N1914A-12

Modification Recommended Service Note

N1914A EPM Series Dual Channel Power Meter

The Problem – Meter Display Brightness Intensity Control Malfunction

0960-3600 and its location:

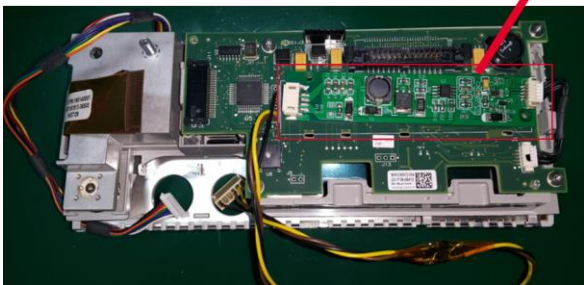
Unit with the serial number stated above is built with LCD backlight driver (0960-3600), and this result in failure to adjust the meter display brightness.

Verify the meter display brightness by access the brightness feature. Press **System, 1 of 2** and select **Service**. In the **Service** menu, press **1 of 2** and select **Backlight**. Press **Brightness + / Brightness -** to increase / decrease the backlight's brightness. If failed to adjust the brightness, refer to the service guide and replace the LCD backlight driver 0960-3600 with 0950-5724.
